GNRO-2010/00056

SUBJECT: License Amendment Request  
Extended Power Uprate  
Grand Gulf Nuclear Station, Unit 1  
Docket No. 50-416  
License No. NPF-29

1. Analysis of Proposed Operating License and Technical Specification Changes
2. Proposed Operating License and Technical Specification Changes (Mark-up)

~~FIGURE 3.1.7-1~~  
~~SODIUM PENTABORATE SOLUTION CONCENTRATION/AVAILABLE VOLUME REQUIREMENTS~~

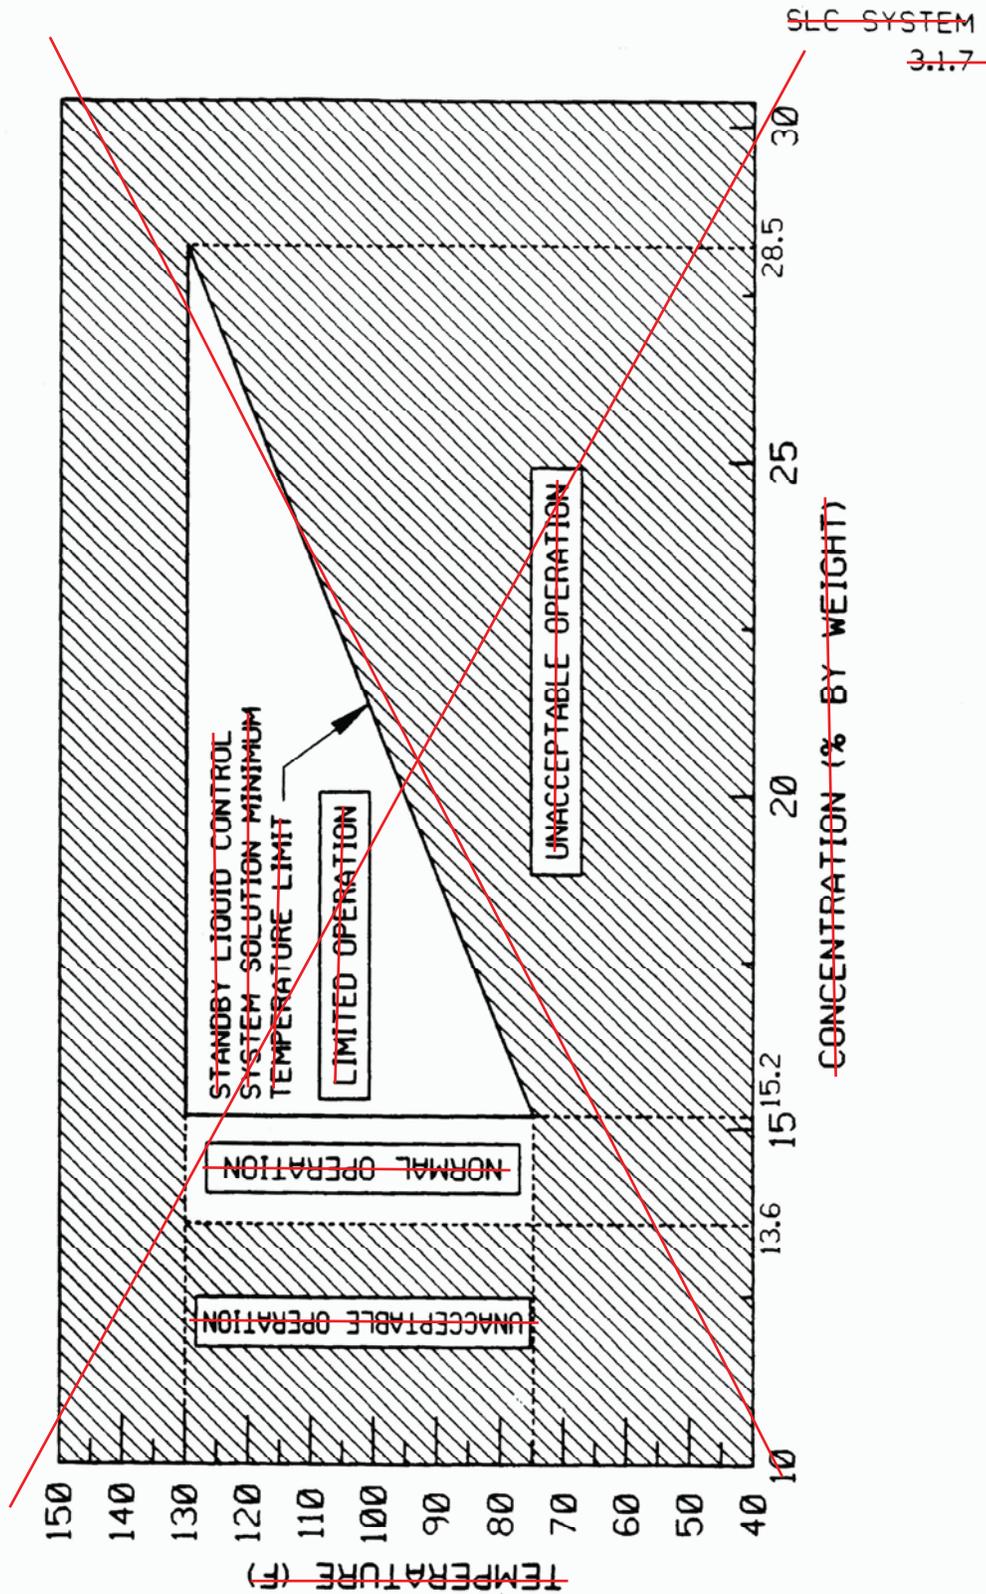
- SR 3.1.7.1 is being revised to verify the available volume of sodium pentaborate solution is greater than or equal to 4,200 gallons. This change results in the deletion of Figure 3.1.7-1. Performance of this SR ensures adequate sodium pentaborate volume is available to inject into the reactor vessel if required.

- SR 3.1.7.2 is being revised to verify the temperature of sodium pentaborate solution is greater than or equal to 45°F and less than or equal to 150°F. This change results in the deletion of Figure 3.1.7-2. Performance of this SR ensures the temperature of sodium pentaborate in the tank and at the pump suction piping (current SR 3.1.7.3) is within specified limits to ensure the capability of the system to inject the boron solution into the reactor vessel if required. The less restrictive lower temperature requirement prevents precipitation considering the reduced concentration requirements in accordance with the sodium pentaborate saturation curve. The upper temperature limit ensures adequate net positive suction head requirements for two pump operation.

In addition to the above, Figures 3.1.7-1 and 3.1.7-2 will be deleted. A note will be added to page 3.1-23 stating that the next page is 3.1-26. This is an administrative change and allows the current TS page numbering to remain the same.

Figure 3.4.11-1 (page 1 of 5)

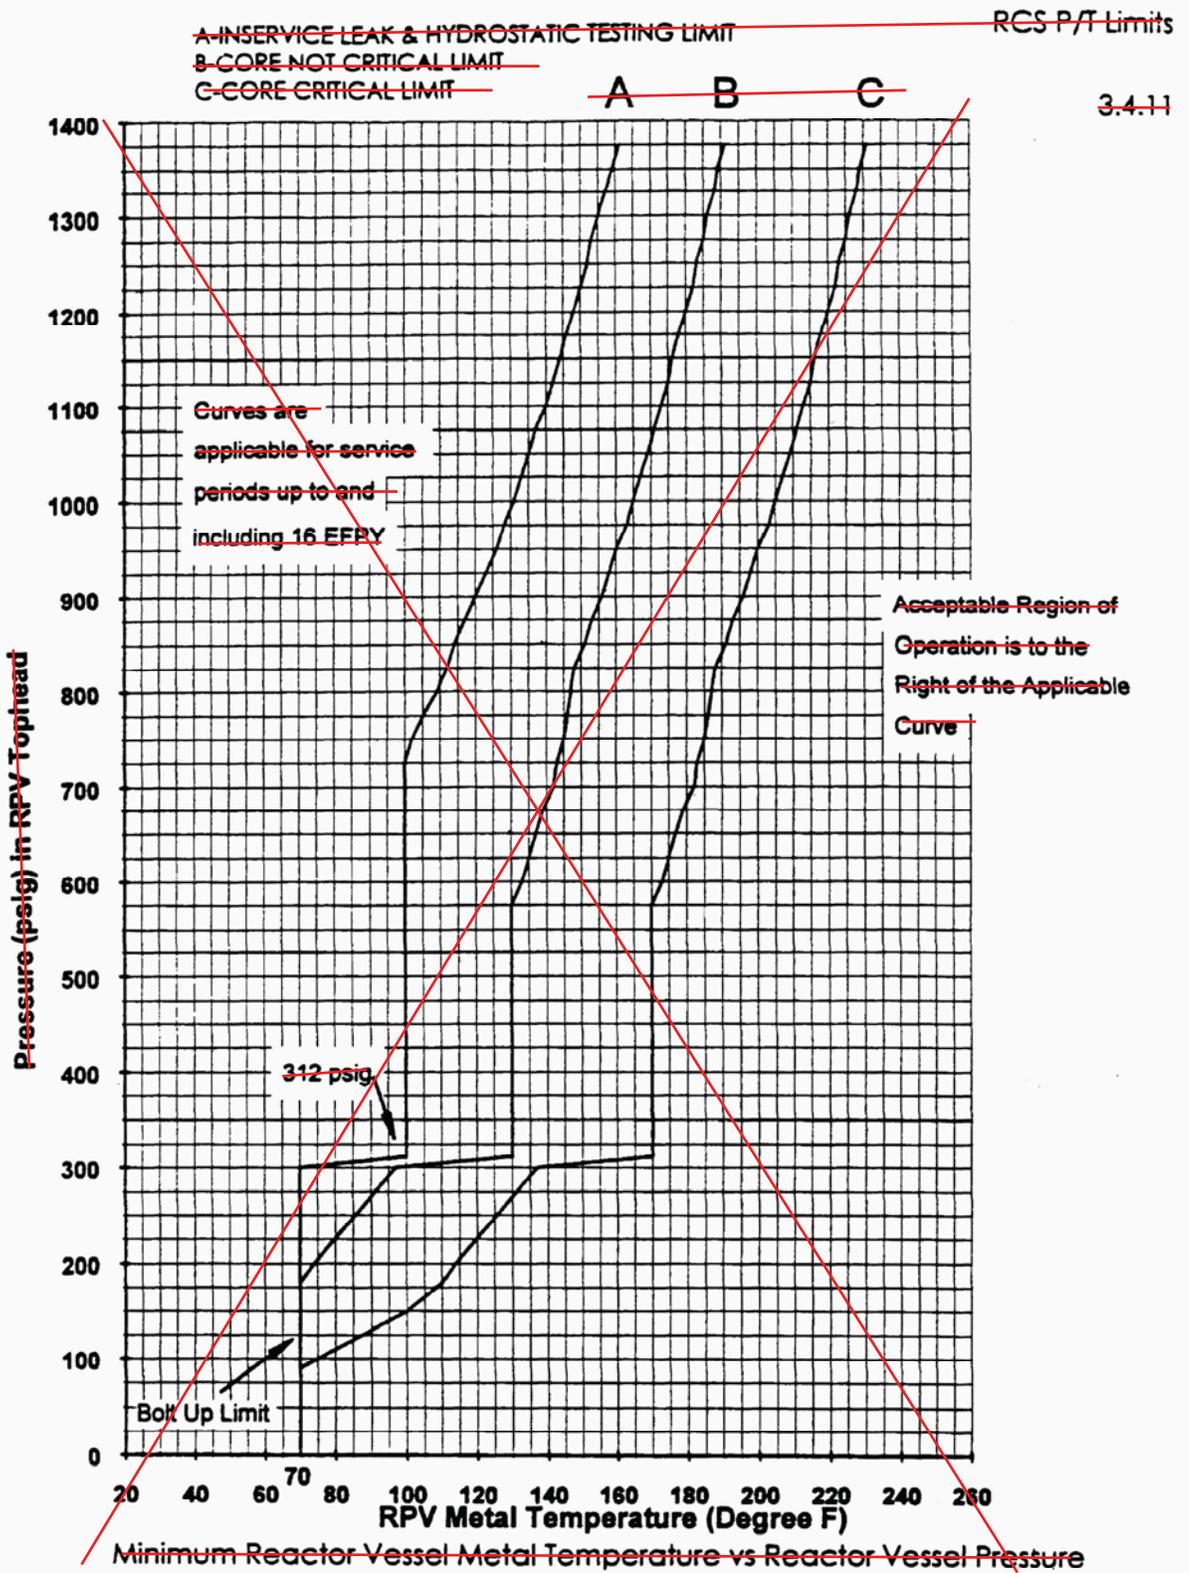
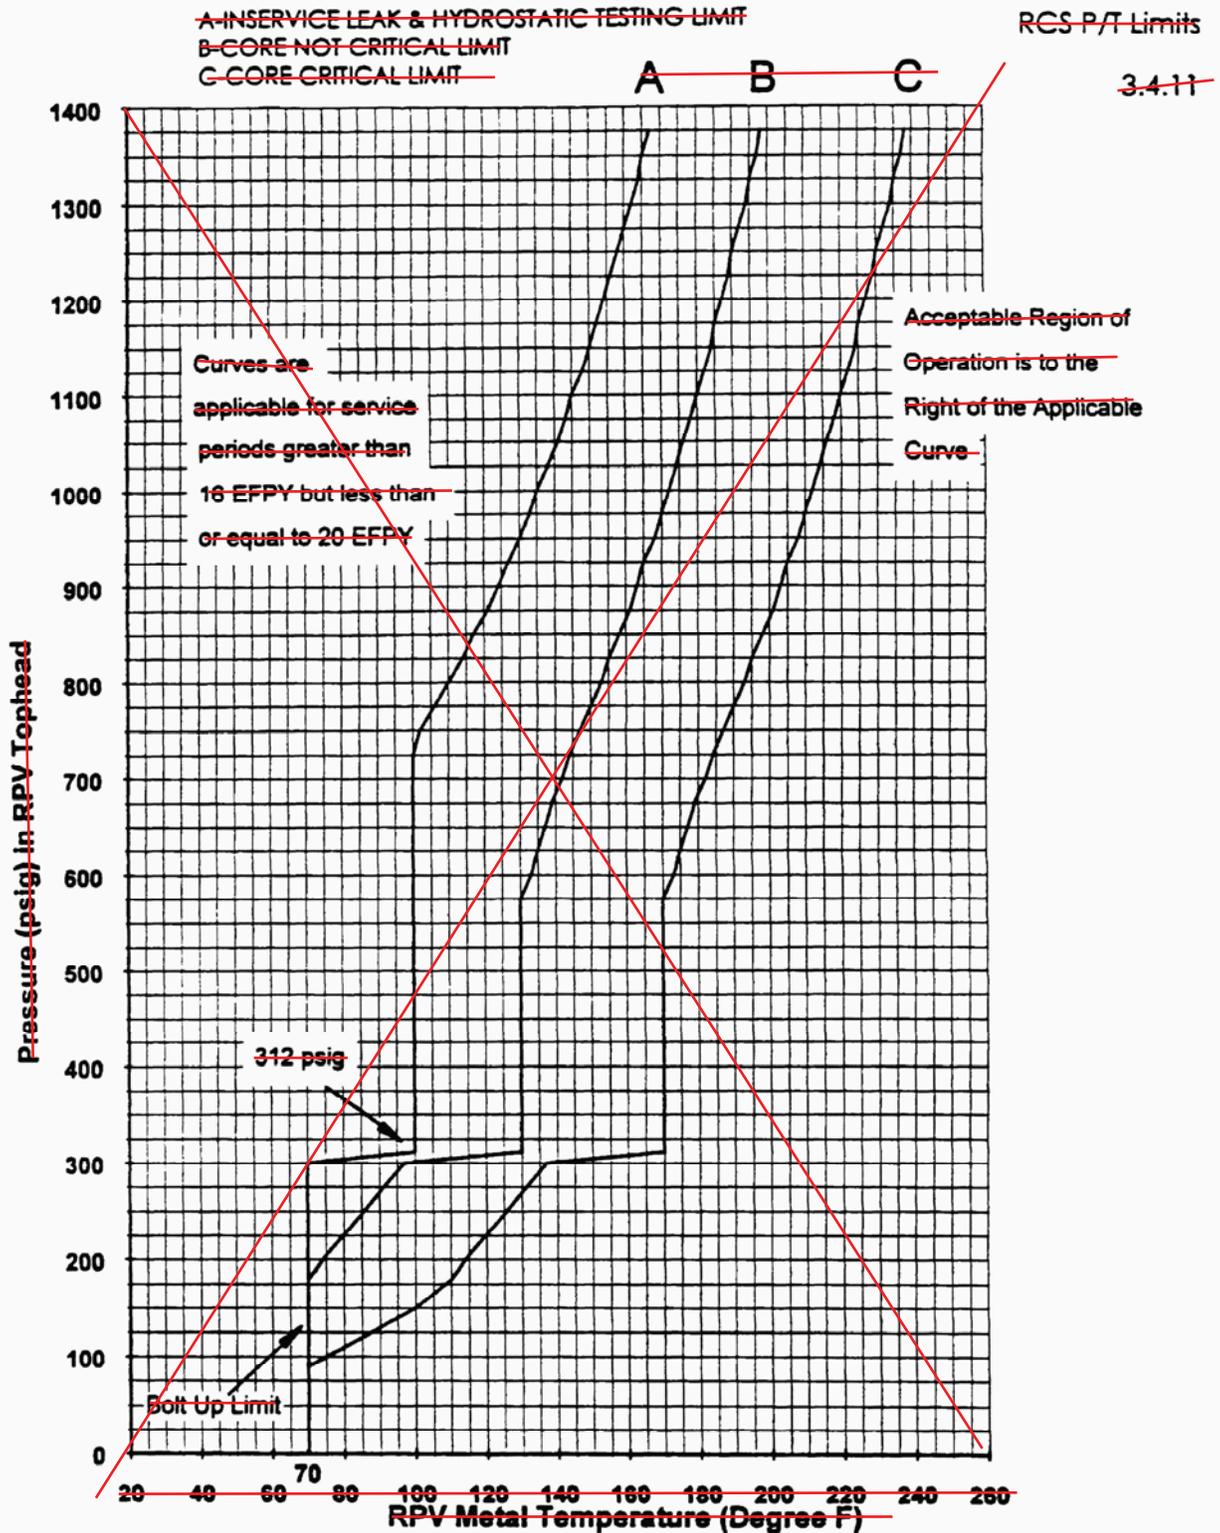
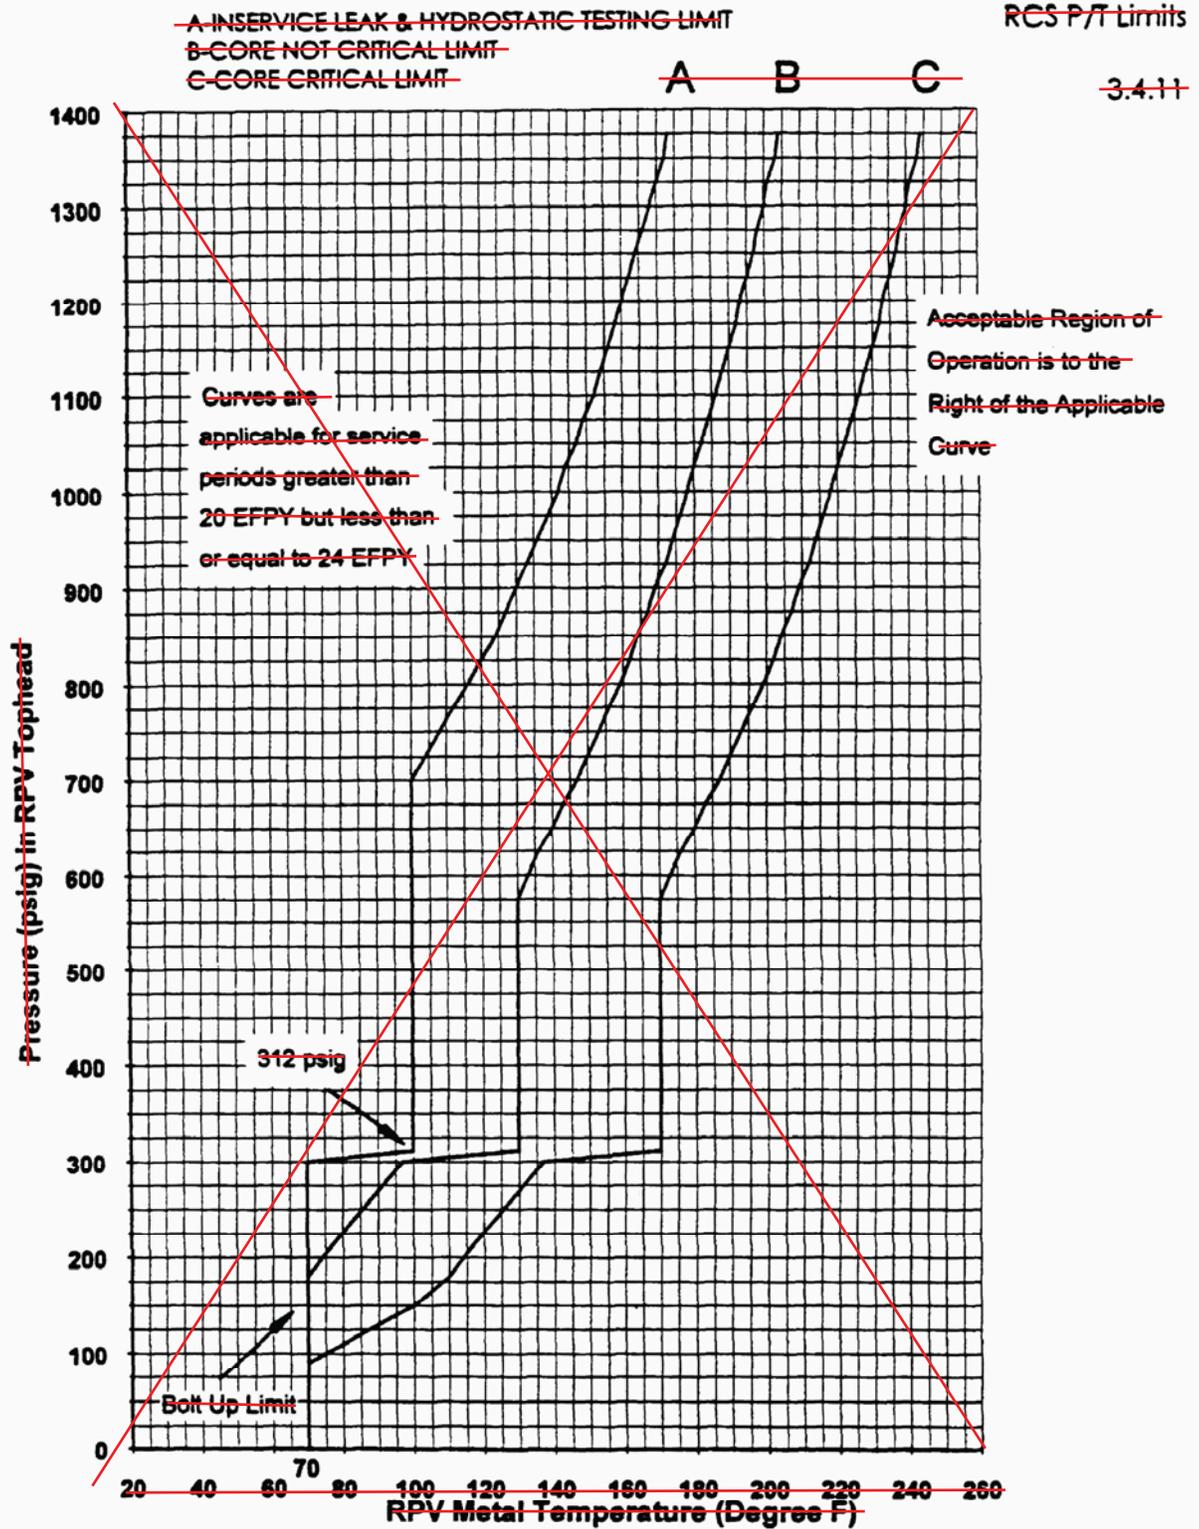
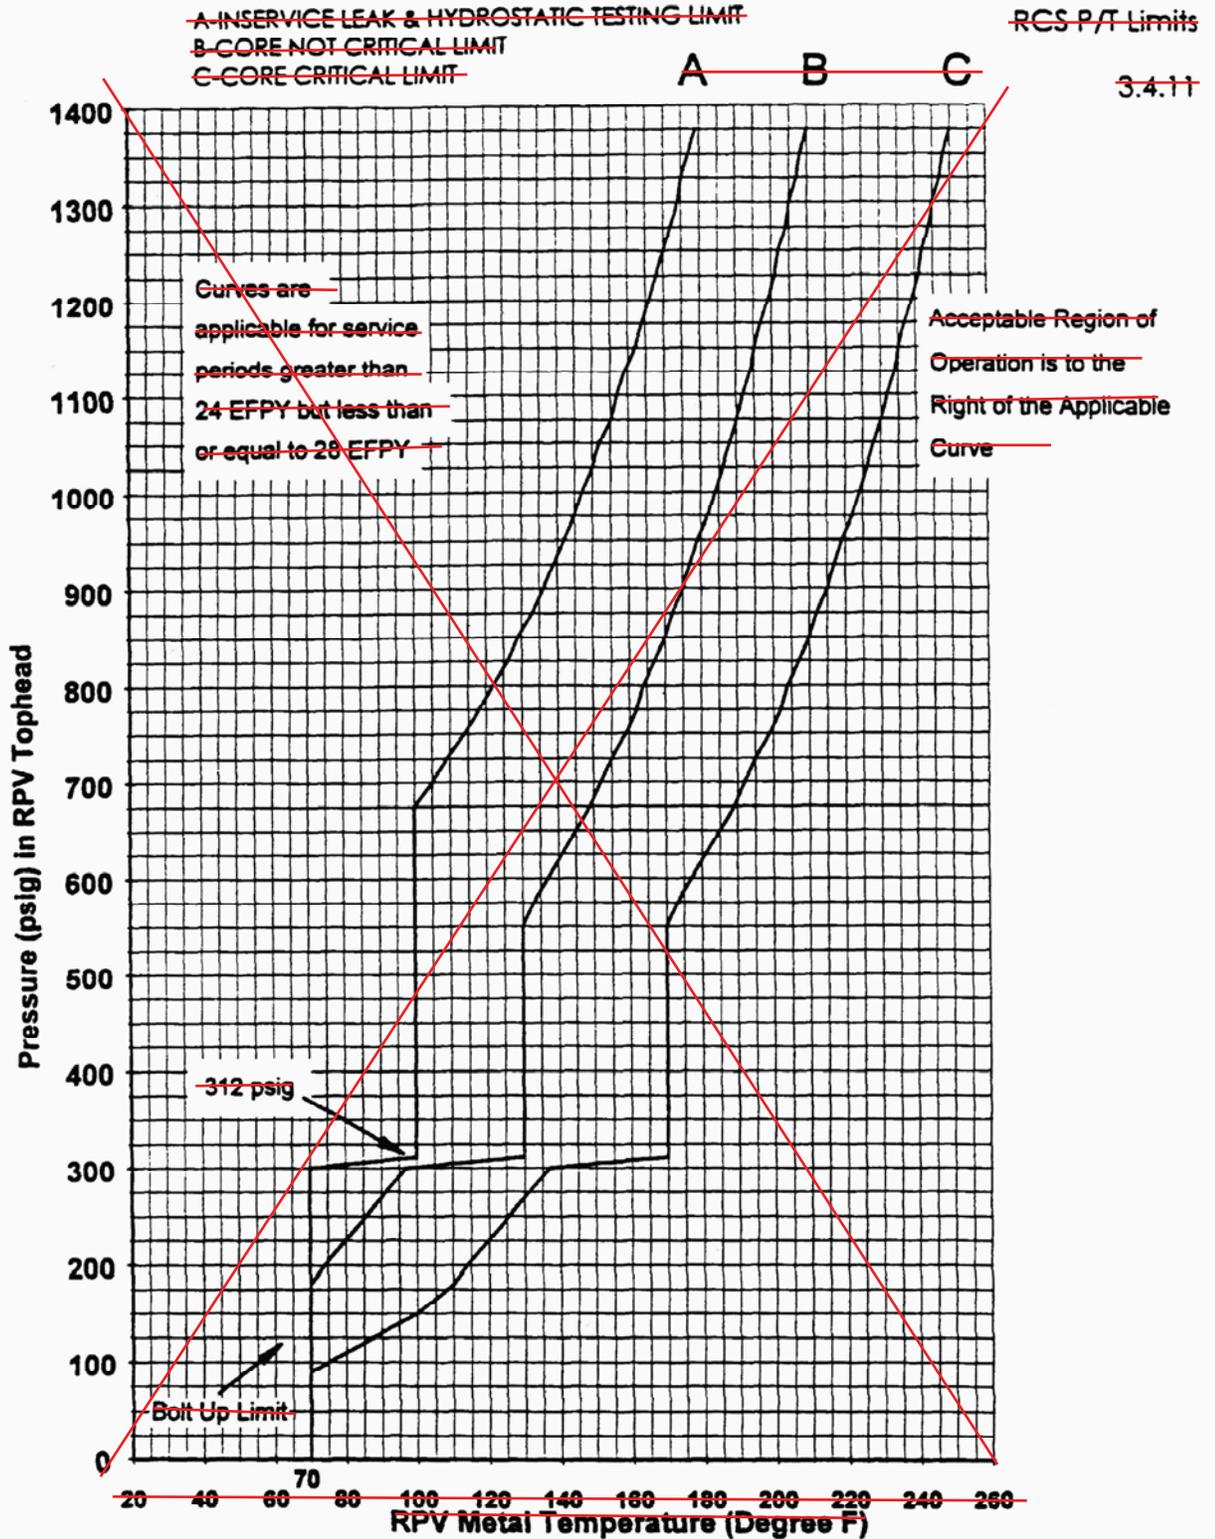
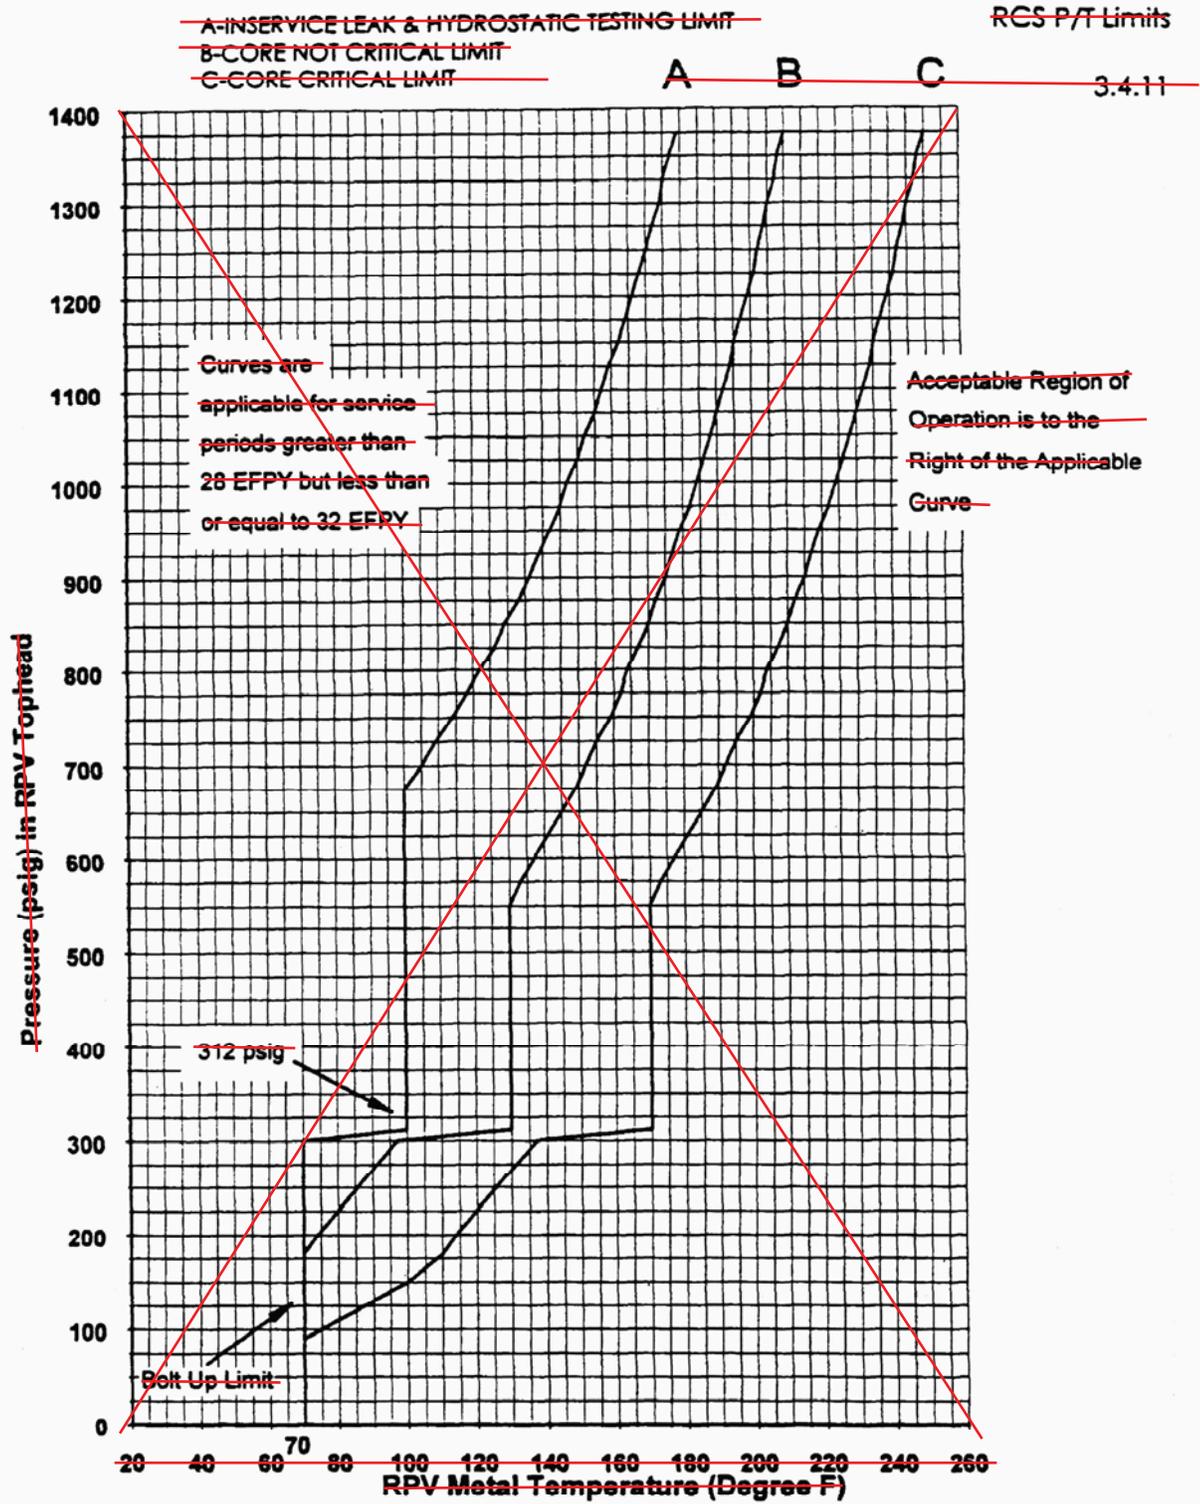
Along with the incorporation of new curves, Entergy proposes the deletion of Figure 3.4.11-1, the P/T limits curves, based on the creation of the PTLR. NRC GL 96-03 (Reference 7) provides guidance that allows the relocation of the RCS P/T curves to a PTLR. The proposed PTLR adopts the methodology described in NRC-approved NEDC-33178P-A, Revision 1, *GE Hitachi Nuclear Energy Methodology for Development of Reactor Pressure Vessel Pressure Temperature Curves* (Reference 8), for preparation of the P/T curves. The following changes are required to support the relocation of the P/T curves to the PTLR:

- Figure 3.4.11, “Minimum Reactor Vessel Metal Temperature vs. Reactor Vessel Pressure,” will be deleted. A note will be added to page 3.4-30 stating “Next page is 3.4-36.” This is administrative in nature and allows the current TS page numbering to remain the same.

- SR 3.4.11.1 a – “within the limits of the applicable Figure 3.4.11-1” will be replaced with “within the limits specified in the PTLR.”
- SR 3.4.11.1 b – “≤ 100°F in any 1 hour period,” will be replaced with “within the limits specified in the PTLR.”

- SR 3.4.11.2 - “... in the applicable Figure 3.4.11-1” will be replaced with “... in the PTLR.”
- SR 3.4.11.3 – “≤ 100°F” will be replaced with “within the limits specified in the PTLR.”
